# Planning Commission Agenda Item

**SUBJECT: ZN-20-2024 CENTENNIAL LOSEE (Public Hearing).** Applicant: Greystone Nevada, LLC. Request: A Property Reclassification of 17.97 Acres from a PUD, Planned Unit Development District to a PUD, Planned Unit Development District, Consisting of 288 Multi-Family Dwelling Units. Location: Northwest Corner of Losee Road and Azure Avenue. (APNs 124-26-501-019 and 124-26-501-020) Ward 2. (For Possible Action)

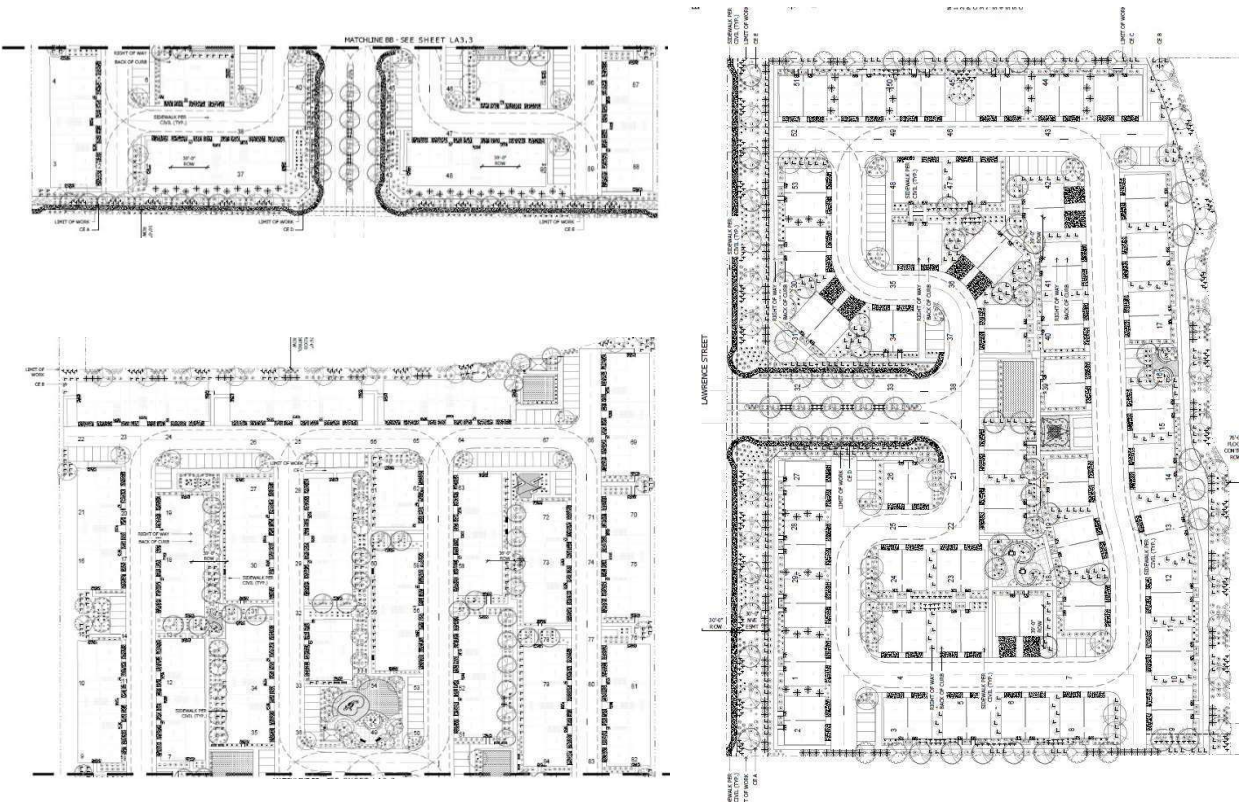
The proposed preliminary development plan indicates the west development's main access and the required secondary fire access from Lawrence Street and the east development will have primary access and secondary fire access from Losee Road.

The proposed landscaping plan indicates the perimeter landscaping of 35 feet along North Lawrence Street including a five (5) foot sidewalk. There is an existing City water line along Lawrence Street, which creates the need for the wider landscaping where the required perimeter landscaping along North Lawrence Street is fifteen (15) feet including a five (5) foot sidewalk. The required perimeter landscaping along Losee Road is twenty (20) feet including a five (5) foot sidewalk. The proposed landscape plan complies with this requirement. The perimeter landscaping appears to be in compliance with code requirements. The proposed landscape plan indicates a view fence is provided along the trail/wash area for both the west and east portions of the development.
